Re: Comments – Kern County Subbasin

**Kern County Subbasin Technical Working Group's Comments
regarding the
Kern County Subbasin Probationary Hearing Draft Staff Report's
preliminary review of the Subbasin's 2024 Plan**

On July 25, 2024, the State Water Resources Control Board (SWRCB) published the "Kern County Subbasin Probationary Hearing Draft Staff Report" (draft Staff Report). The Kern County Subbasin Groundwater Sustainability Agencies (Kern GSAs) tasked the Technical Working Group (TWG) with reviewing and providing initial technical comments regarding the draft Staff Report's preliminary review of the final draft amended Kern County Subbasin Groundwater Sustainability Plan (2024 Plan).

Figure 1. Water level transect along cross section E-E' comparing Fall 2015, MO, and MT groundwater elevations.

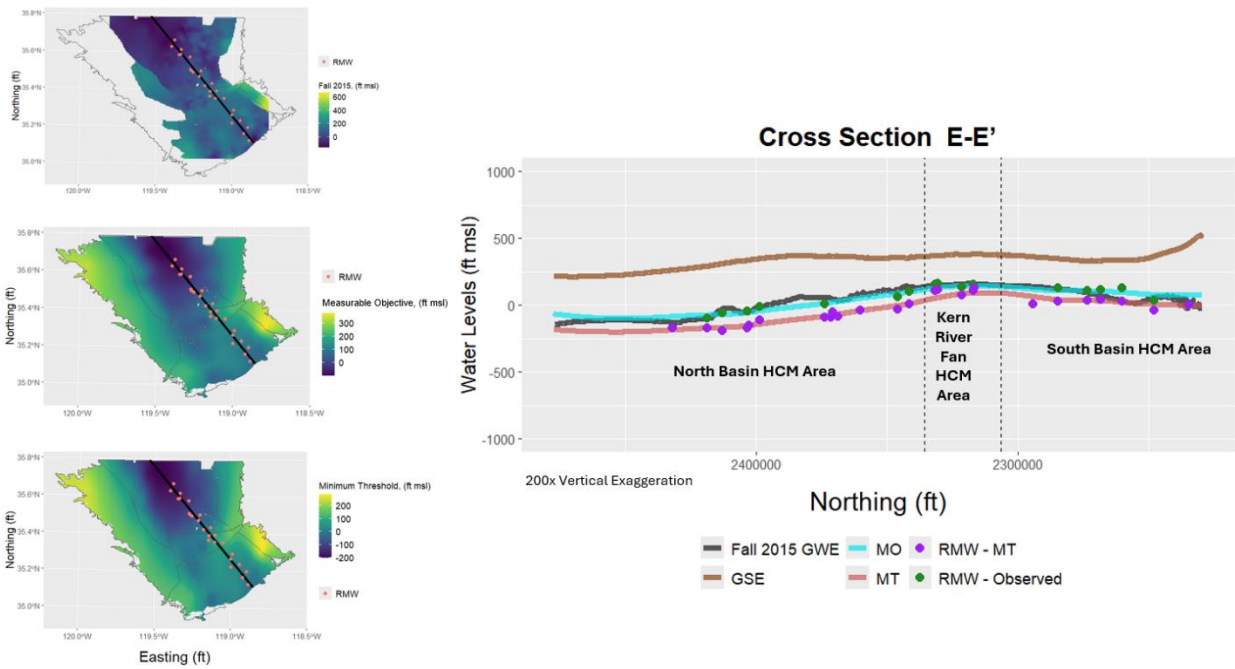
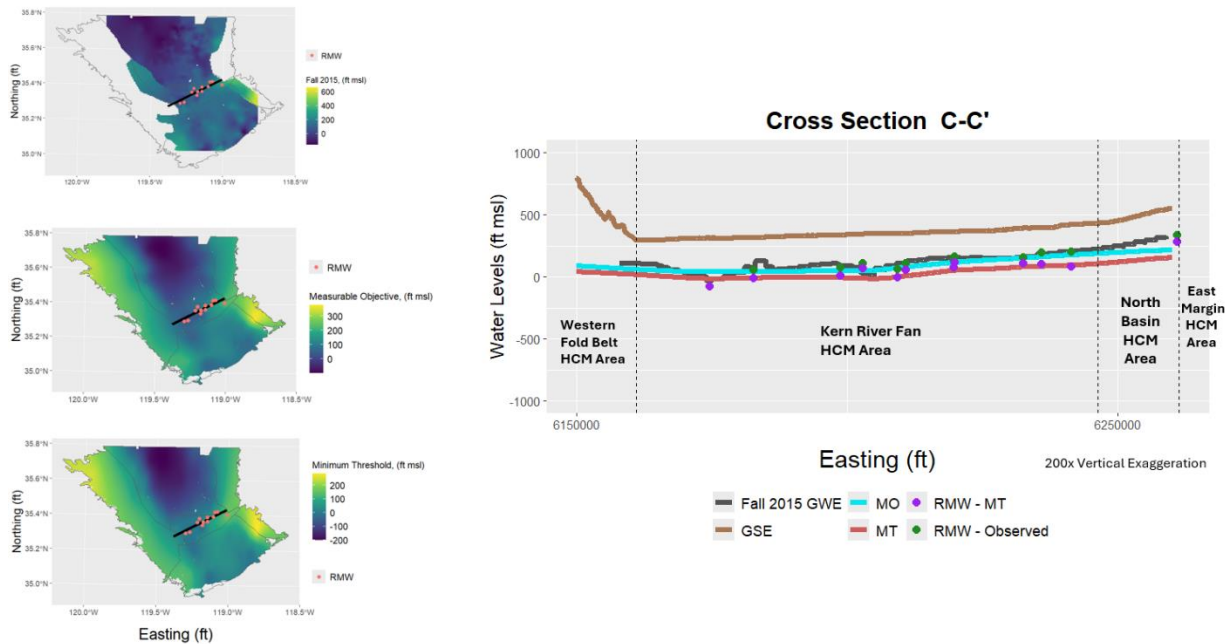
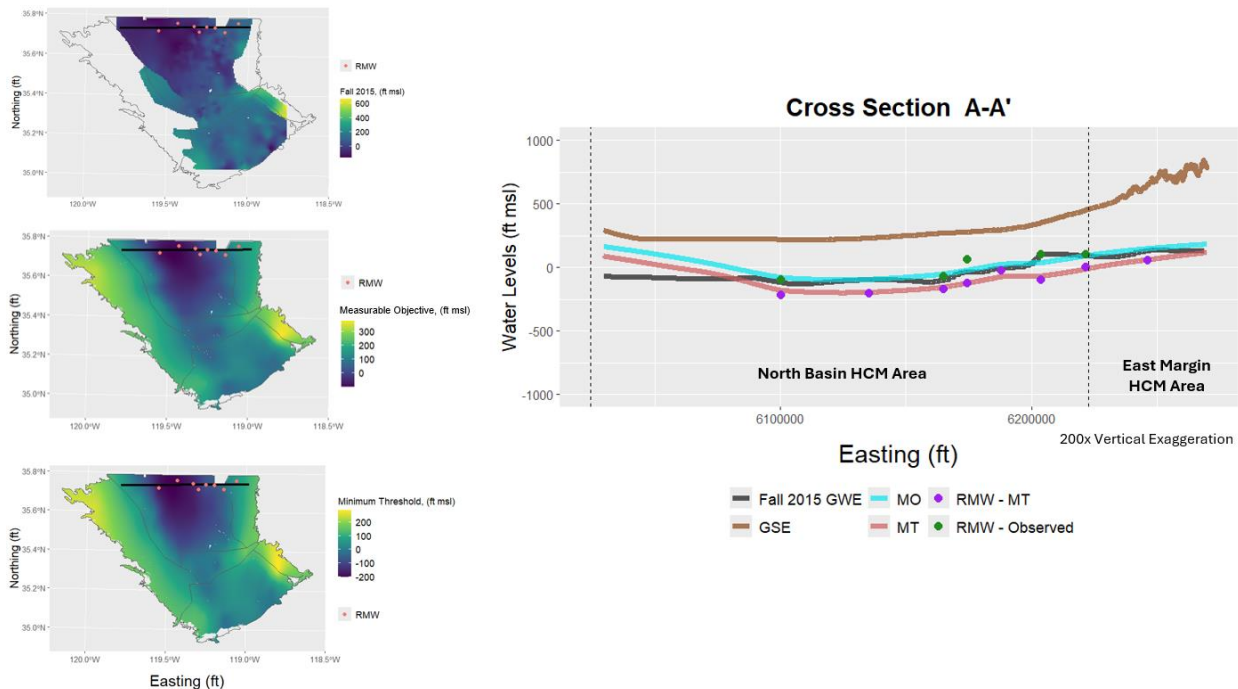
- Board staff note that the use of regionally-averaged declining elevation trends leads to groundwater level MTs that vary dramatically across “hydrological areas” of the subbasin and may have resulted in a skewed (heavily weighted toward areas of more pumping and lower elevation) approach in setting MTs. This results in inconsistent management action triggers across plan areas, an issue previously identified by DWR across the 2022 GSP plan areas due to lack of coordination (Consistent with Coordination deficiency 1a).*

The SWRCB Draft Staff Report states that the “groundwater level MTs ... vary dramatically across ‘hydrological areas’ of the subbasin”. As shown in the contour maps and the three transects Figure 1, Figure 2, and Figure 3 below, the MT (and MO) values in fact do not “vary dramatically” between HCM Areas. They instead appropriately reflect the localized water level conditions across the Subbasin similar to those observed in Fall 2015. Similarly, spatial interpolations of the MTs and MOs at RMWs are similar to the Fall 2015 water level spatial interpolation. It should be noted

that the transects show smooth MT and MO interpolated values, and some of the apparent discrepancy at the RMW points is related to the translation across up to a two-mile distance to the transect lines.

FIGURE 3.2-7. Analysis of Past Operations: Time vs. Affected Area Outside the Kern Water Bank Exceeding ± 5 Feet Differences in Groundwater Elevations (“With Kern Water Bank Operations” Minus “Without Kern Water Bank Operations”), 1995-2014

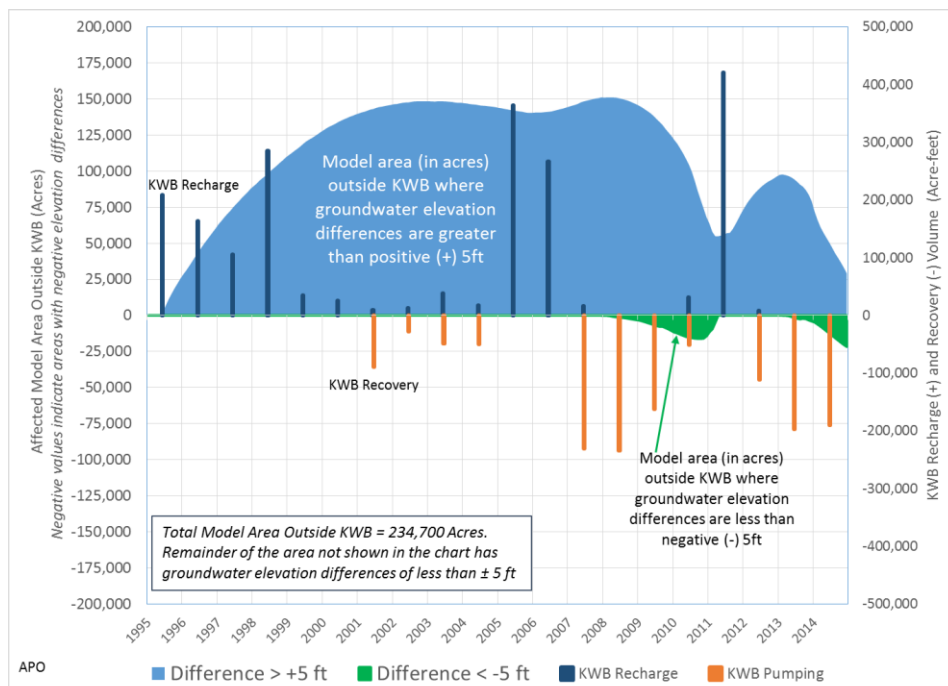
- *Plans lack clarity on banking operations and how they impact the ability of the basin to avoid hitting MTs. This is especially true given that the GSPs' Appendix E, Kern Fan Water Banking Program, stated that, "[t]he Projects cannot cause chronic lowering of groundwater levels or a reduction in storage" (2024 Draft Main GSP, Appendix E. p. 7) (Groundwater Level deficiency).*

DWR conducted an in-depth analysis of KWB operations in a 2016 Environmental Impacts Report (EIR) which included modeling the potential impacts of the KWB project for the 1995-2014 period. An analysis of with project operations and without project operations documented the effects of the project on adjoining areas. These effects are most simply summarized on Figure 3.2-7 which illustrates the area outside the KWB where changes in water levels exceeded 5 feet, either up or down, as a result of project operations. As shown, groundwater levels for significant areas outside the KWB were greater than 5 feet throughout the entire period under the with project operations scenario. Groundwater levels were lower than 5 feet for some areas for limited times toward the end of significant droughts.

Following the 1995-2014 period, there were three recovery periods and three significant recharge events. The volumes of water in these later recharge events exceeded those from previous recharge events, the recovery volumes were similar to or less than the 2012-2014 recovery period, and groundwater levels responded in a manner similar to those in the 1995-2014 period. Therefore, it would be expected that these later operations would raise groundwater levels in adjoining areas to the extent shown in Figure 3.2-7 through 2023. In addition, the operations of the other Kern Fan projects (Pioneer, Berrenda Mesa, and West Kern) are analogous to KWB operations, so it follows that the same chronic raising of groundwater levels has occurred as a result of these projects. Notably, at the end 2023, the volume of water in storage in the four projects approached 2 million acre-feet.

Figure 5. Long-term Groundwater Levels and Land Subsidence (Sites A through D)

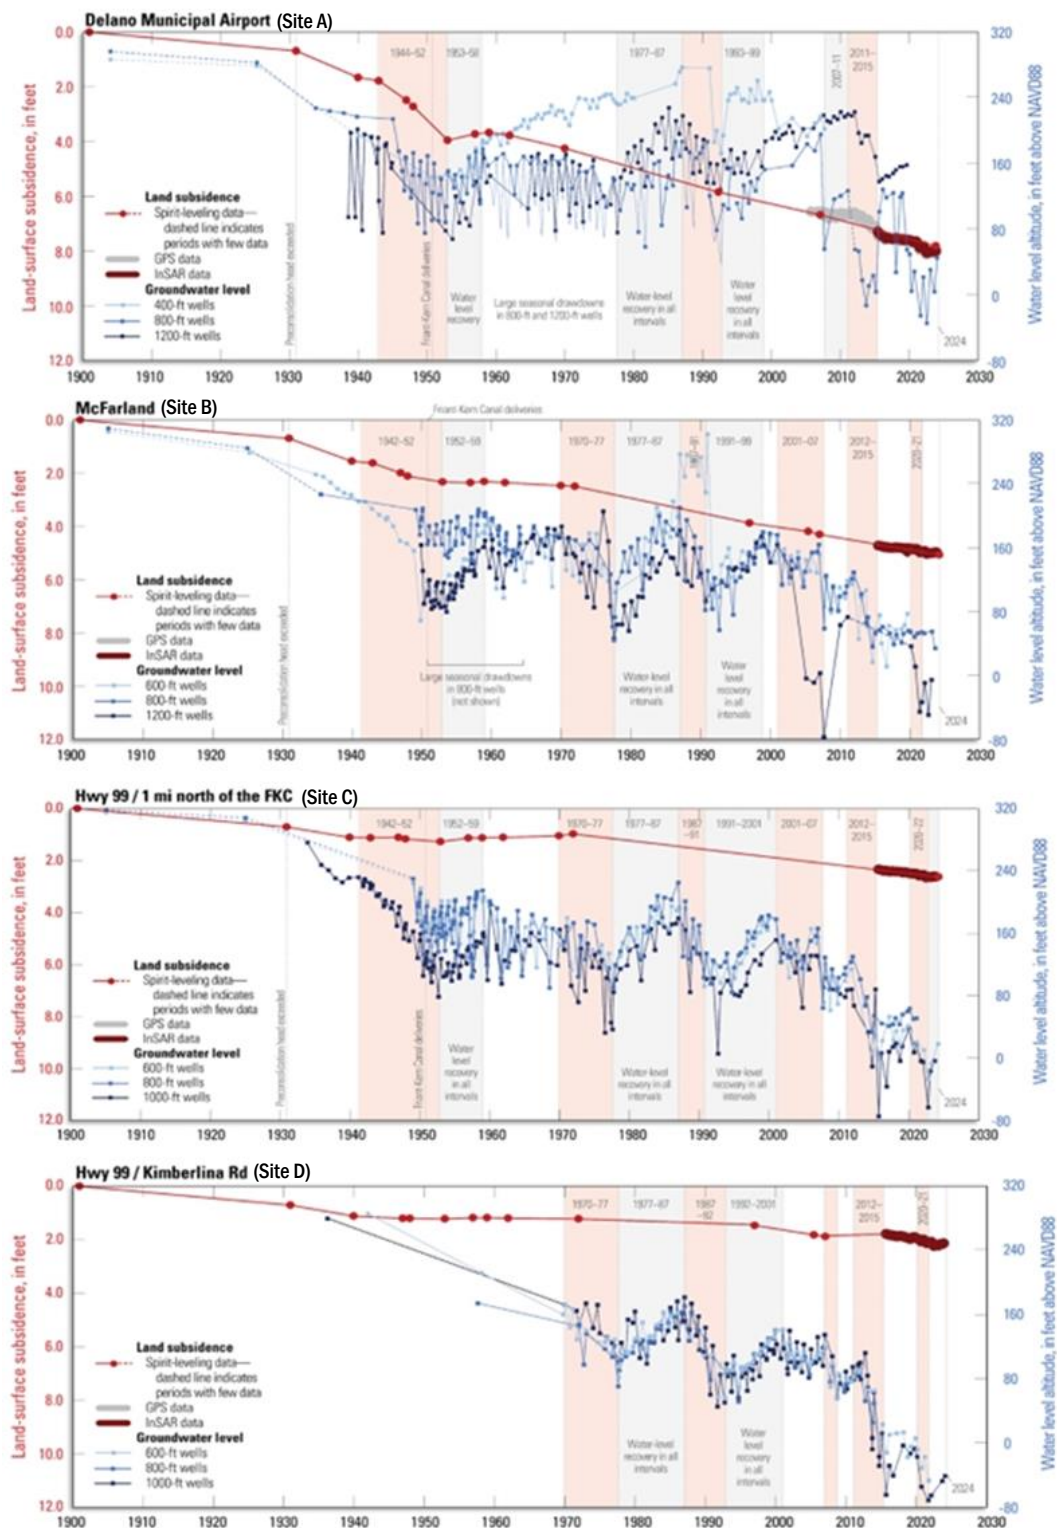
- *The GSAs do not demonstrate a fundamental understanding of the Subbasin’s settings. For example, monitoring well networks for groundwater levels and groundwater quality do not differentiate between confined and unconfined aquifers separated by the E-clay (a confining layer), or other clay layers. Most monitoring wells appear to be screened in the confined aquifer, and therefore may not be protective of all beneficial users when water levels in the unconfined aquifer are lower than that in the confined aquifer. An understanding of groundwater levels and groundwater quality in the unconfined and confined aquifers, as well as subsidence and groundwater quality, is essential for characterizing hydrogeologic conditions throughout the subbasin. Well impact analyses, monitoring plans, or mitigation strategies developed without this knowledge are insufficient and may not be protective of beneficial*

uses and users (Consistent with Groundwater Level and Groundwater Quality deficiencies).

For the 2024 Plan, the alluvium was defined as a single principal aquifer rather than subdividing it into upper and lower principal aquifers based on the actual mapping and analysis of the extent and thickness of the E-Clay. Figure 4 illustrates the lack of E-Clay along the Kern River Fan area. Utilizing maps of the E-Clay extent from the USGS and others (Croft 1972, Page 1983, 1986; PGA 1991), it was determined that the E-Clay is absent in over 60% of the Subbasin. In another 30%, the E-Clay is either discontinuous or near the margins, where zones above and below it are hydraulically connected (see Figure 7-24 of the 2024 Plan). Thus, given the limited and discontinuous nature of the E-clay, the aquifer system functions as a single principal aquifer with some local zonation influenced by the E-Clay and other clay layers (see Sections 7.2, 7.3 and 7.4), and was appropriately defined as such.

A distinct separation in groundwater levels due to the E-Clay is observed in an area along the boundary with the Tule and Tulare Lake Subbasins, covering about 10% of the Subbasin. Here, groundwater above the E-clay flows southeastward towards regions where the E-Clay is discontinuous, merging with groundwater below. This area is designated as a conservation easement for the Kern National Wildlife Refuge, which is supported by surface water. Given the lack of groundwater use in this area, it does not qualify as a separate principal aquifer. In contrast, the Tule and Tulare Lake Subbasins define upper and lower principal aquifers due to the E-Clay forming a continuous layer over 60% and 100% of their respective areas. Furthermore, in these

The variability of the E-Clay justifies establishing a single principal aquifer for the alluvial sediments. This is based on a fundamentally sound understanding of the Subbasin-wide hydrogeology. As an example of the hydraulic relationship along the northern fringe of the Subbasin, Figure 5 on the following page shows a series of hydrographs and land subsidence of nearby wells for four areas along Highway 99. The Delano Municipal Airport (Site A) is the furthest northern site within 2 miles of the boundary with the Tule Subbasin and shows examples of zonation among three aquifer zones at variable depth by location. The Highway 99 at Kimberlina Road (Site D) is the farthest southern location and only about 13 miles south of the Delano Airport. At the Delano Municipal Airport site, the groundwater elevations in the shallowest screened zone are higher than the lower zone at times but are nearly the same at other times. This relationship indicates the effects of local zonation as evidenced by increased subsidence at Site A compared to the other three sites that have similar groundwater elevations over the period of record. At the three more southern locations, the difference between the shallower and deeper screened intervals is minimal indicating little to no local zonation in these areas. The smaller magnitude of subsidence observed at the three southern sites compared to Site A is because the E-Clay and lesser clay layers diminish to the south (Figure 4). These wells provide an example of the observed hydraulic response observed in the Subbasin near the Friant-Kern Canal. While localized vertical head differences are present in some areas of the Subbasin, the alluvial aquifer at the Subbasin-scale is

hydraulically connected and can be managed as a single aquifer system.
